ADDENDUM ONE

Addendum One (AD.01) to the drawings and specifications prepared by Gibraltar Design for **Early Learning Center (ELC) and Alternative Learning Center (ALC) Additions and Renovations** for Tippecanoe School Corporation, Lafayette, Indiana.

1 G-301 3/8" = 1'-0"

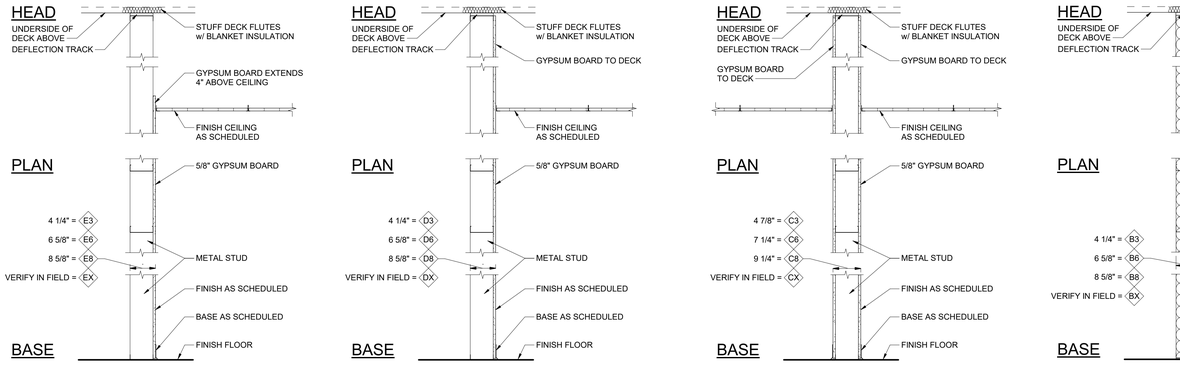
10. **Sheet G-301**
    A. Refer to revised, full-size drawing, included in this Addendum, for revisions.
       1. Wall Partition Notes: Change Note 2 to Read "Not Used".

DRAWING
ARCHITECTURAL FIRST FLOOR DEMOLITION PLAN

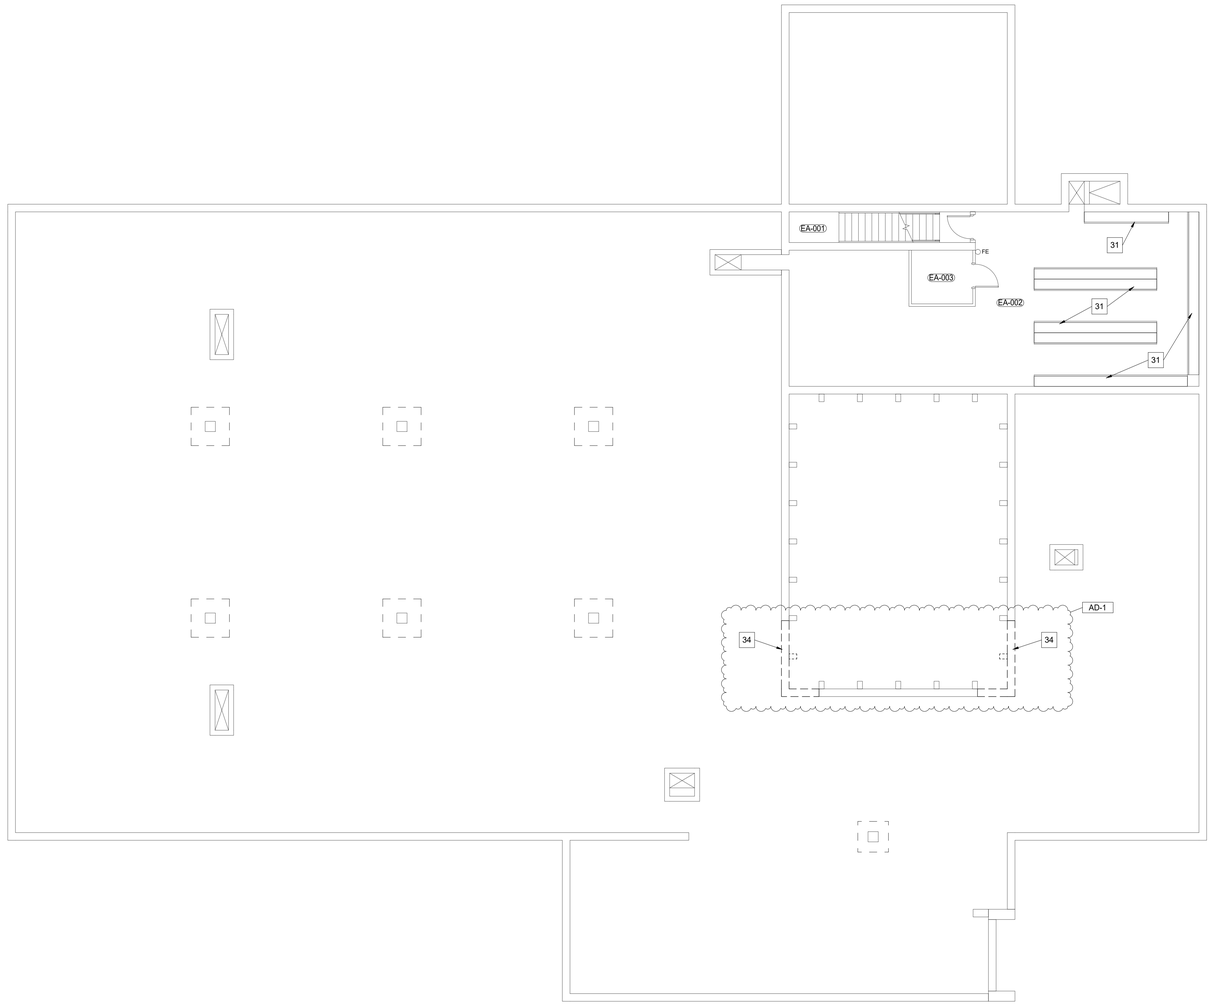
1. Architectural First Floor Demolition Plan 1: Modify floor slab demolition for footing installation.

5 A-401 **FASCIA DETAIL**
3" = 1'-0"

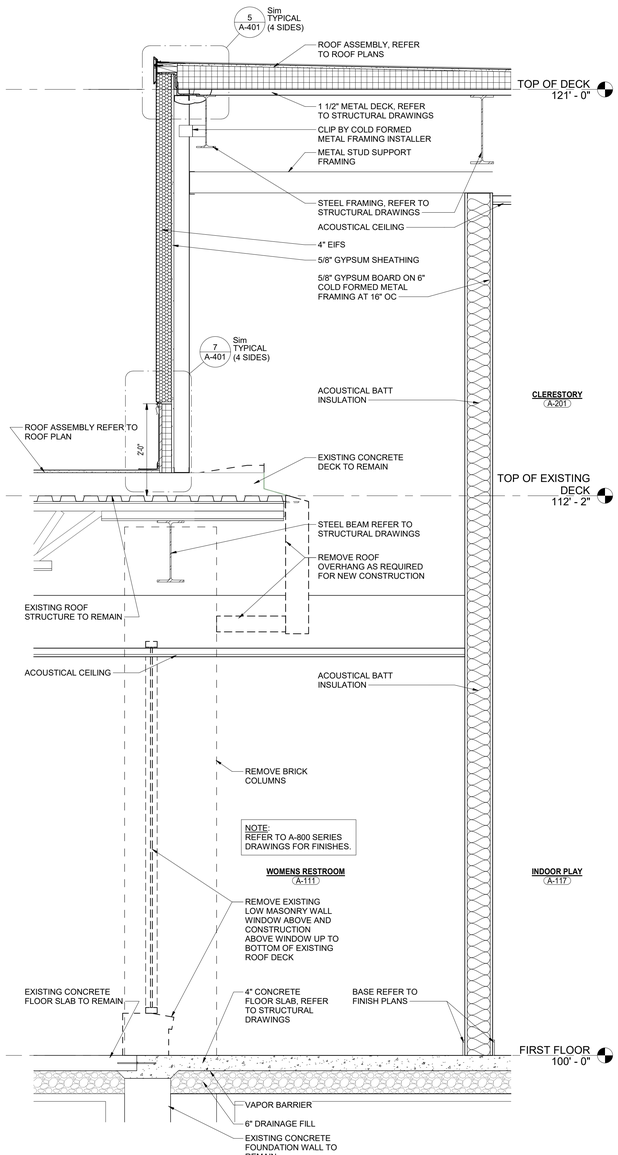
1. Fascia Detail 5: Delete "over air barrier" from 4" EIFS Note.
2. Wall/Roof Counter Flashing Detail 7: Add spray foam insulation Note to detail.

DRAWING
MECHANICAL HVAC FIRST FLOOR PLAN

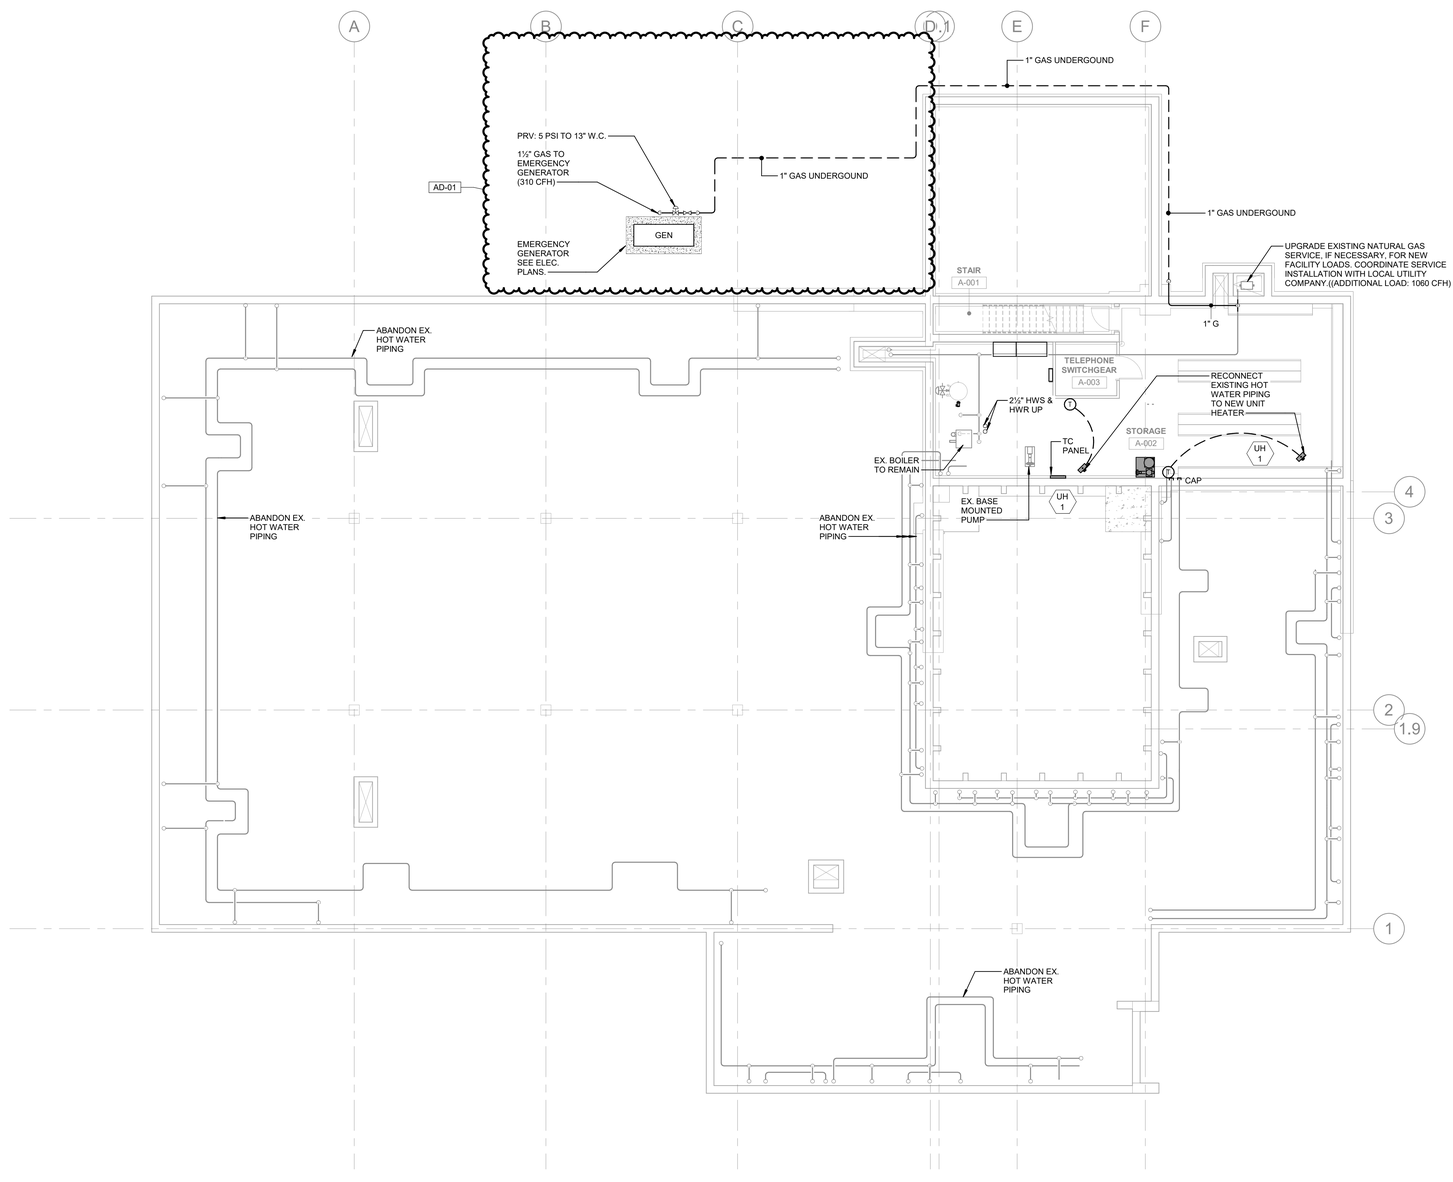
1. Revised ductwork sizes on supply air and return air ductwork to work with structure.
2. Revised ductwork sizes and layout on supply air to work with ceiling space.
3. Revised location of ECH-2.
4. Revised supply air diffuser CFM value for Conference Room A-102.

DRAWING
PLUMBING SCHEDULES

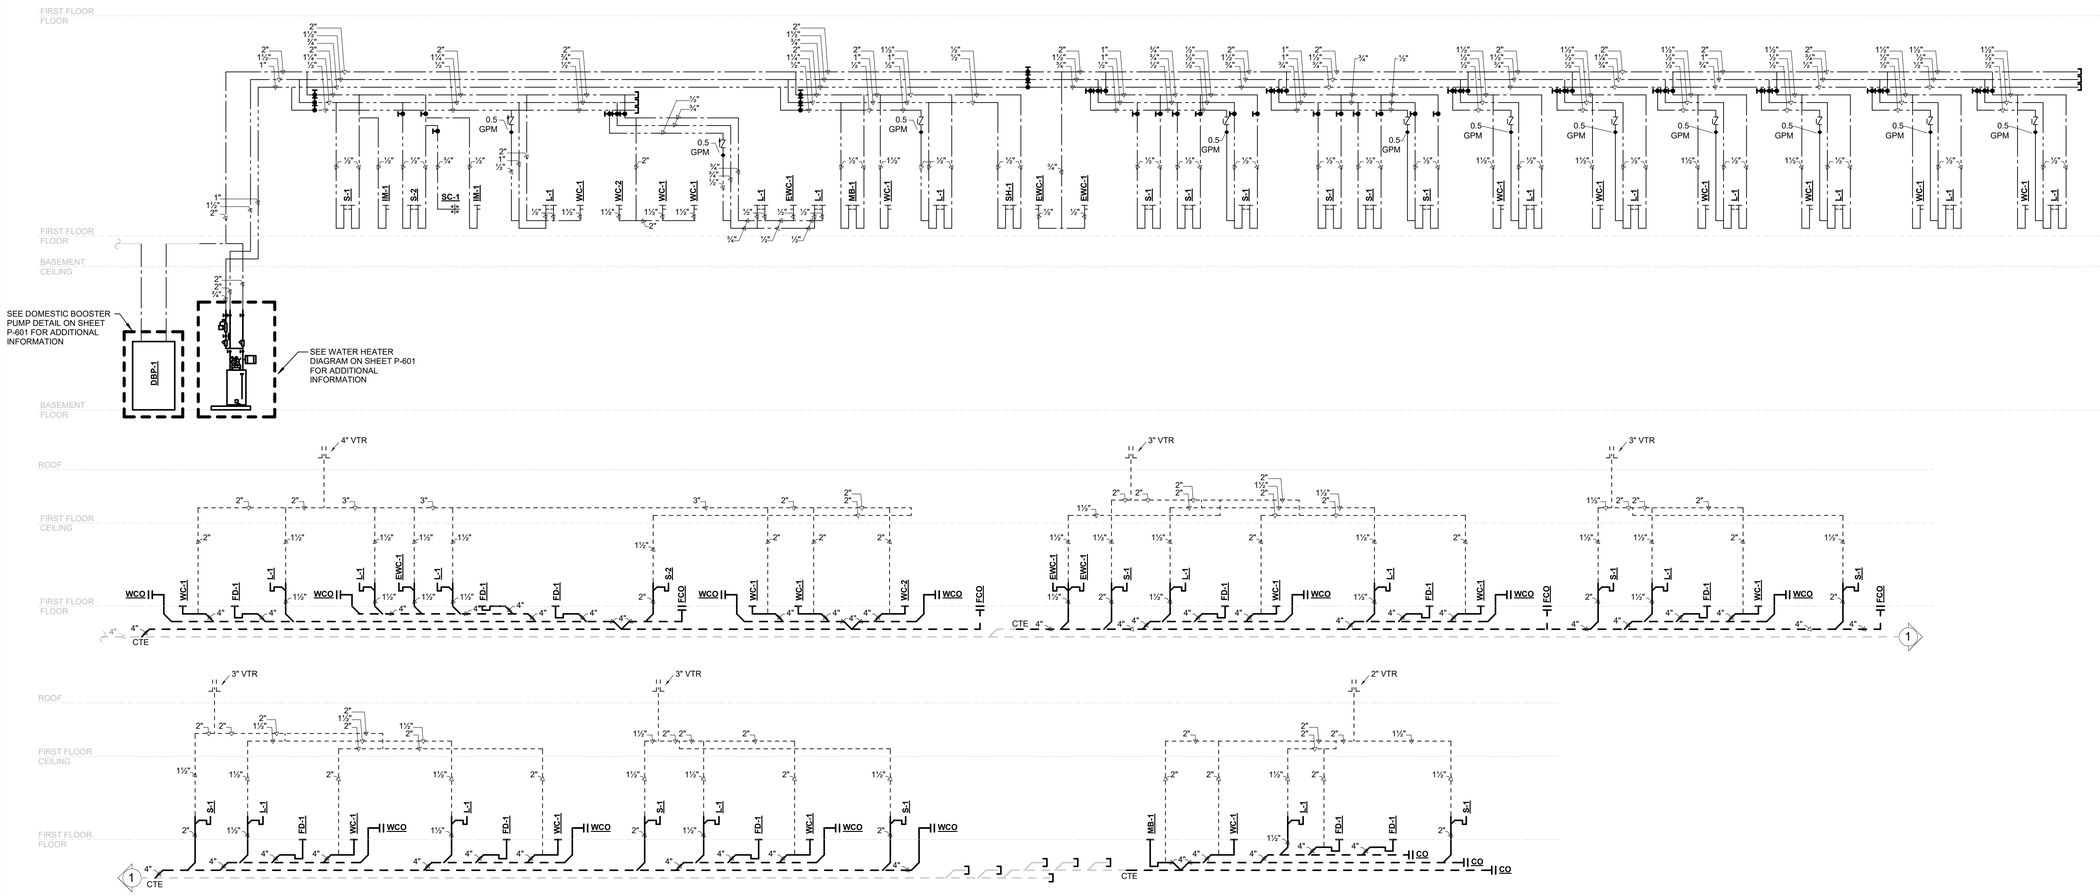
1. Revised SH-1 in Plumbing Fixture Schedule.
2. Removed roof and overflow drains from fixture schedule.
3. Revised Plumbing Fixture Schedule Notes.

DRAWING
ELECTRICAL LIGHTING FIRST FLOOR PLAN

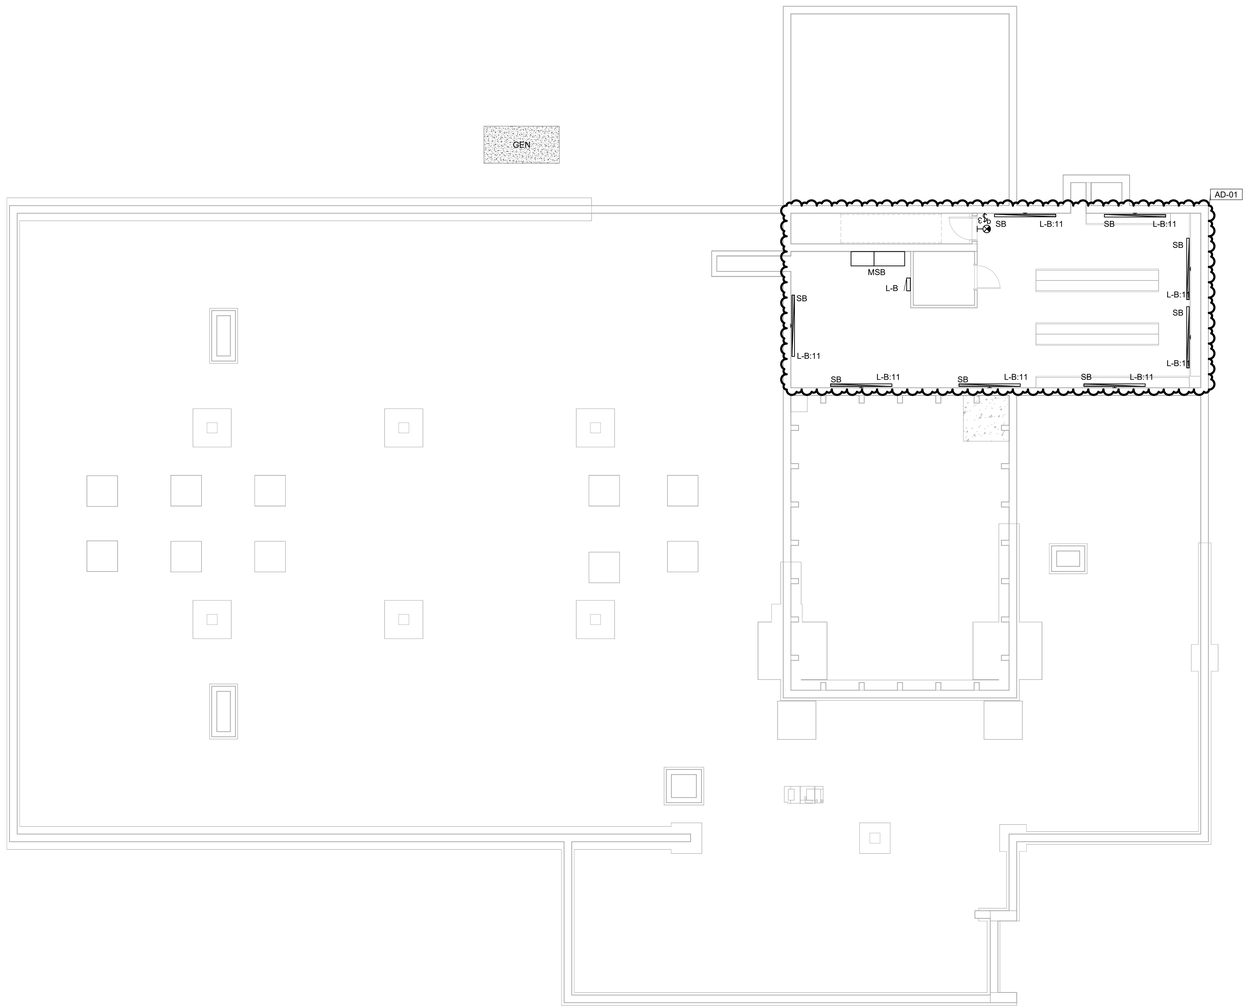
1. Added type CC fixtures outside of classrooms.
2. Shifted type AB lighting fixtures in classrooms.
3. Revised fixture tags to type BA/BB in corridors.
4. Revised lighting layout in Conference and Commons.

SHEET
C-003

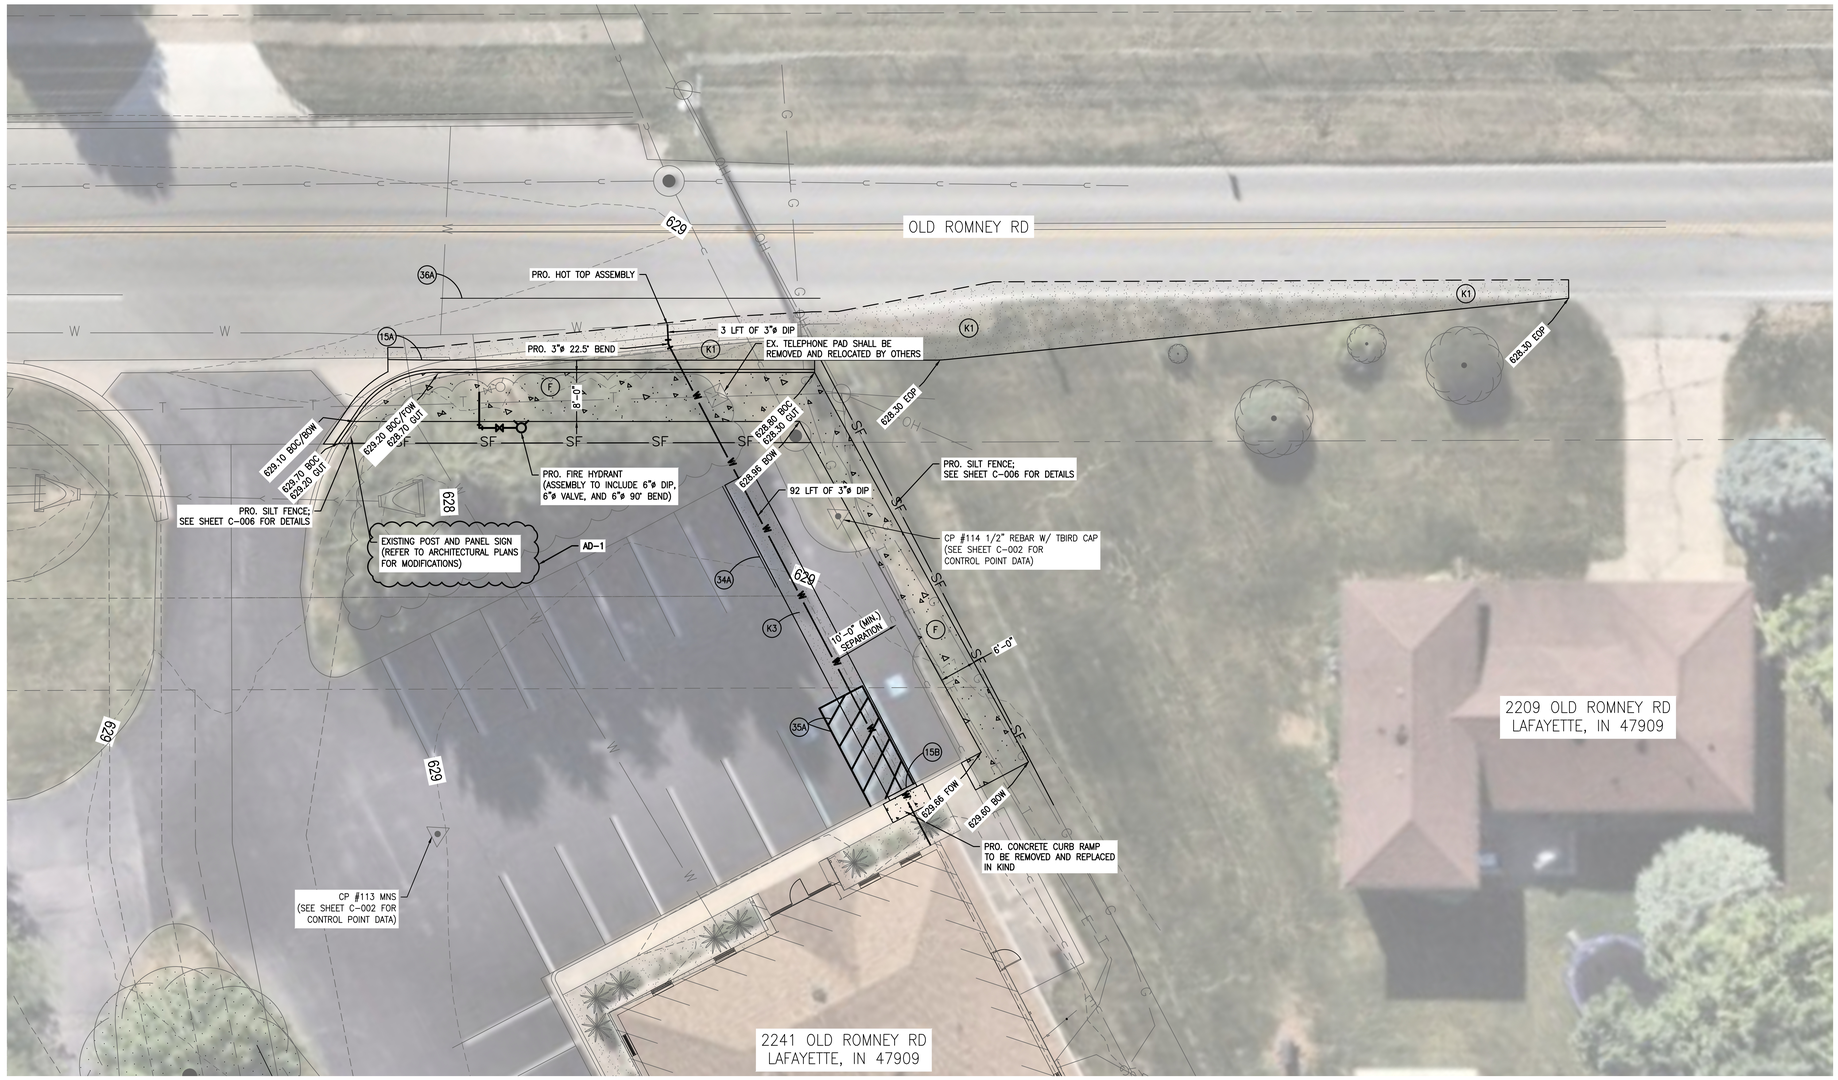
11. **Sheet C-003**
    A. Refer to revised, full-size drawing, included in this Addendum, for revisions.
       1. Add note to remove existing light poles.

2. Add sawcut and curb removal.
       3. Add note to remove curb and sidewalk.
12. **Sheet C-004**
    A. Refer to revised, full-size drawing, included in this Addendum, for revisions.

1 A-101 ARCHITECTURAL FIRST FLOOR PLAN

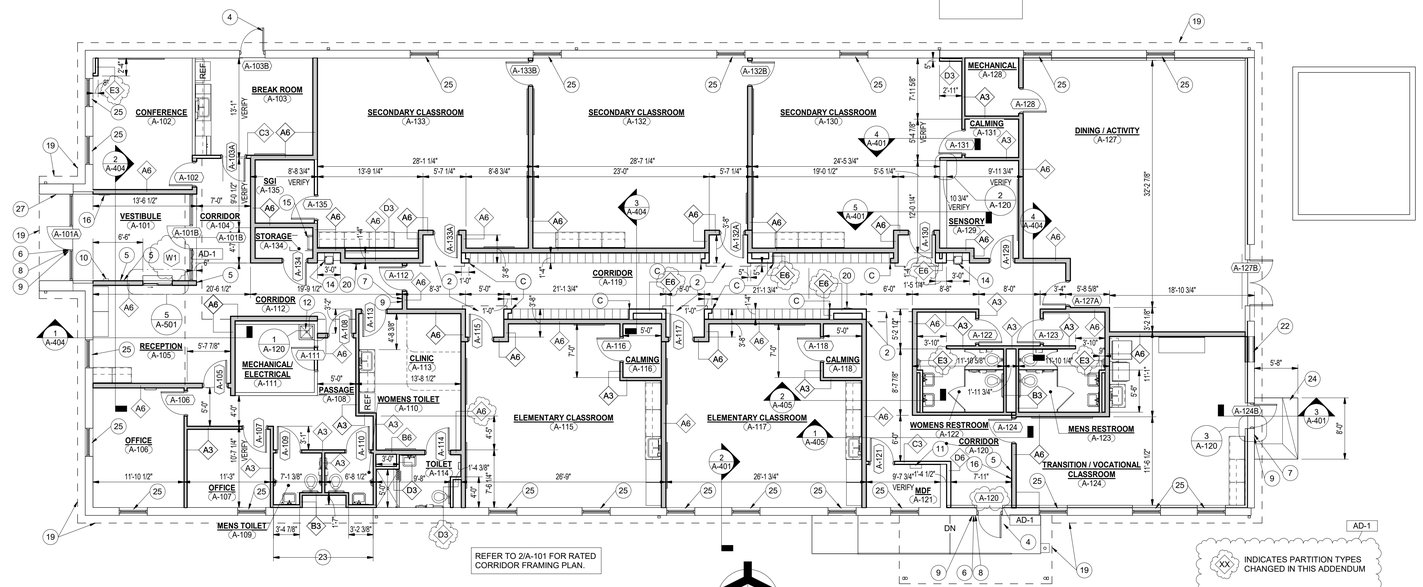
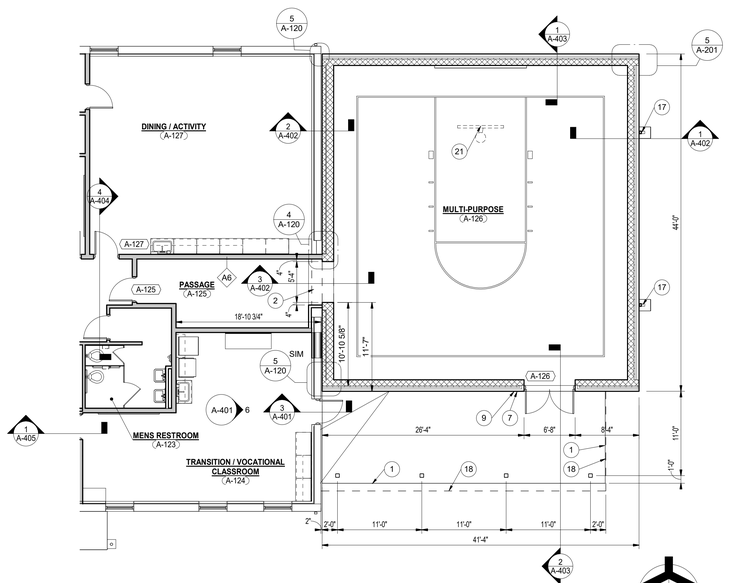
1. Architectural First Floor Plan 1: Revise Wall Partition Types.
2. Architectural Attic Plan: Add Plan Note "28" regarding Attic Ladder removal.
3. Add Window Tag "W1" to Transaction Window in Vestibule A-101.
4. Add Door Tag "A-120" to Exterior Door in Corridor A-120.
